STATE OF MAINE
DEPARTMENT OF TRANSPORTATION
16 STATE HOUSE STATION
AUGUSTA, MAINE 04333-0016

February 20, 2020
Subject: Septic Tank Pumping &
Pump Station Maintenance Work
State WIN: PH20200205R4P
Location: **Region 4**
Amendment No. 1

6'-0" I.D. PRECAST PUMPING STATION
NO SCALE

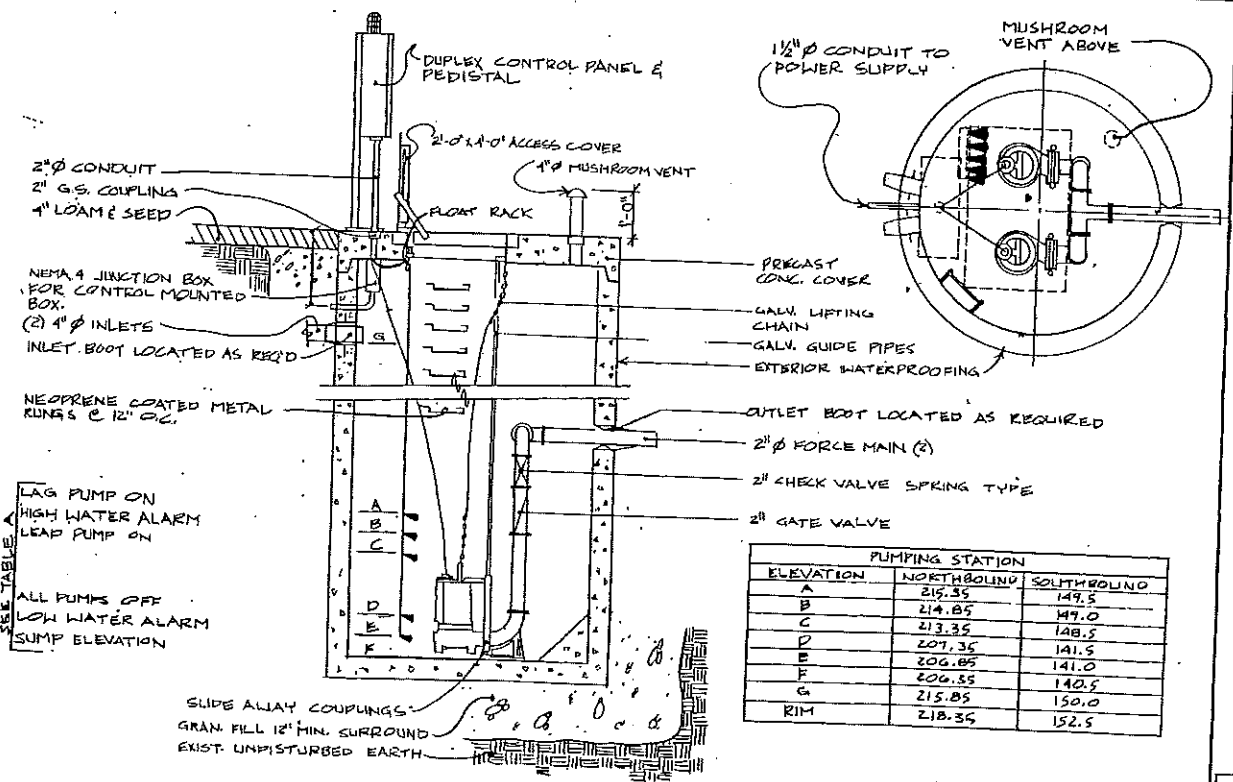
Question: Regarding the pump station maintenance work for the Hermon NB and SB I-95 Rest Areas, are they single or two pump systems?

Question: Regarding the pump station maintenance work for the Hermon NB and SB I-95 Rest Areas, what is the depth to pumps?

Question: Regarding the pump station maintenance work for the Hermon NB and SB I-95 Rest Areas, what is the size of pumps (HP)?

Response: For the rest areas in Hampden, there are two (2) pump systems, see attached diagram.

Response: For the rest areas in Hampden, Northbound is 13 feet to the top of the pumps, and the Southbound is 11 feet to the top of the pumps.

Response: For the rest areas in Hampden, the Northbound pump is ½ HP, 1750RPM, 24HD@40GPM; the Southbound pump is ½ HP, 3450RPM, 33HD@40GPM. See attached diagram.
